Application Number: 09/924,762

For: THE METHOD OF SERVO WRITING
FOR MAGNETIC RECORDING SYSTEM,
MAGNETIC RECORDING SYSTEM

LETTER TO DRAFTSPERSON

FIG. 4(a)

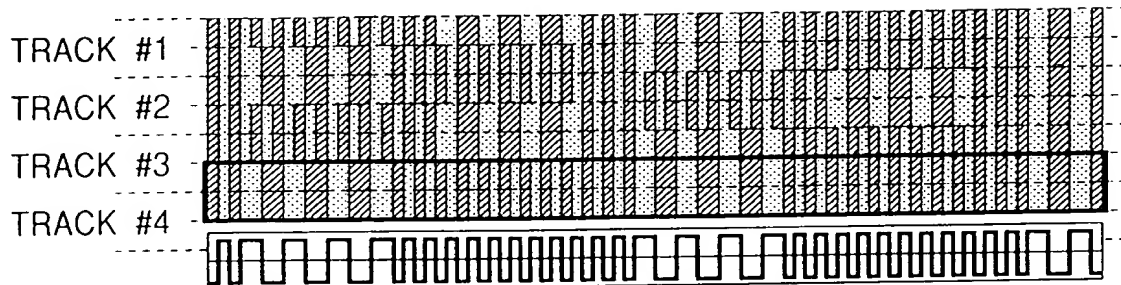
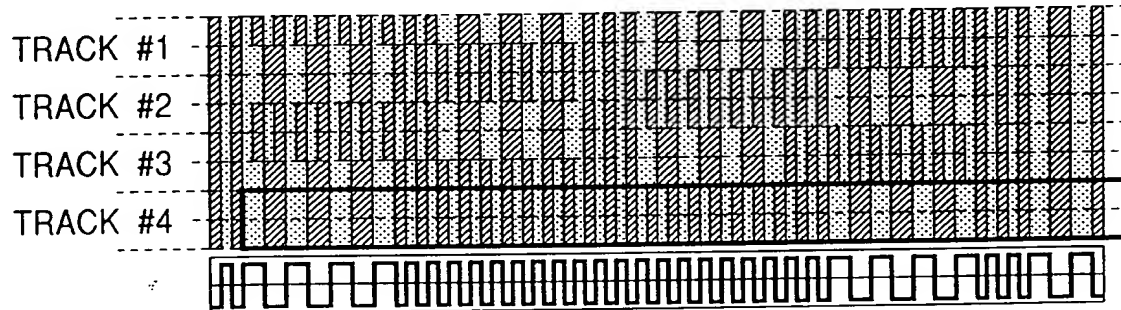
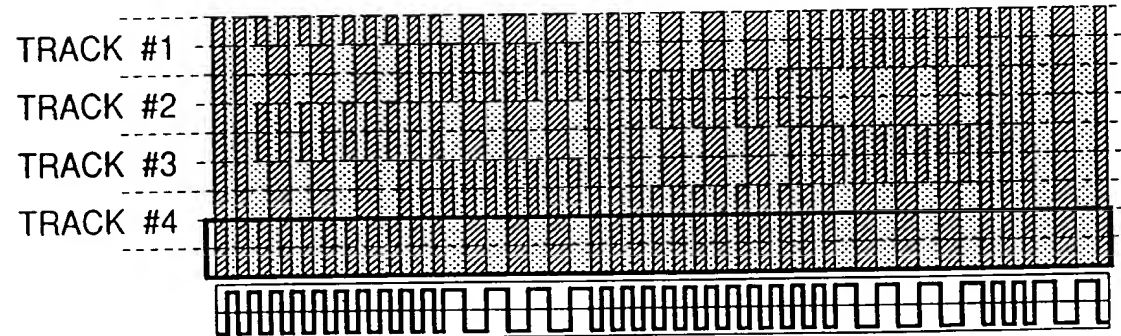
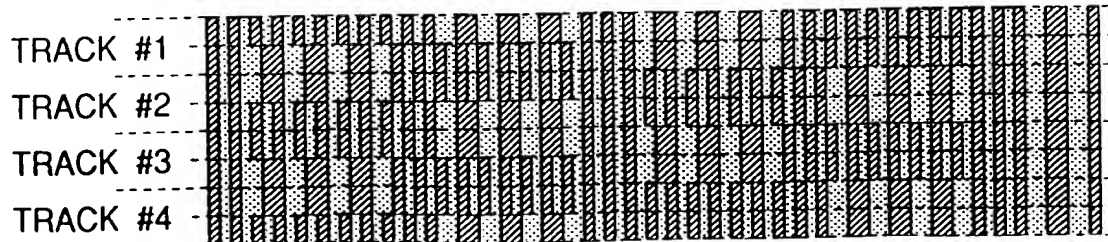
In response to the requirements set forth in the Notice of Draftperson's Patent Drawing Review enclosed with the Office Action mailed on December 10, 2003, Applicant is submitting replacement drawings for Figures 4 and 18. The views have been consecutively renumbered and are believed to be in compliance.

Please replace the drawings for Figures 4 and 18, with the views consecutively renumbered (a)-(d). A Letter to Draftsperson is also submitted herewith.
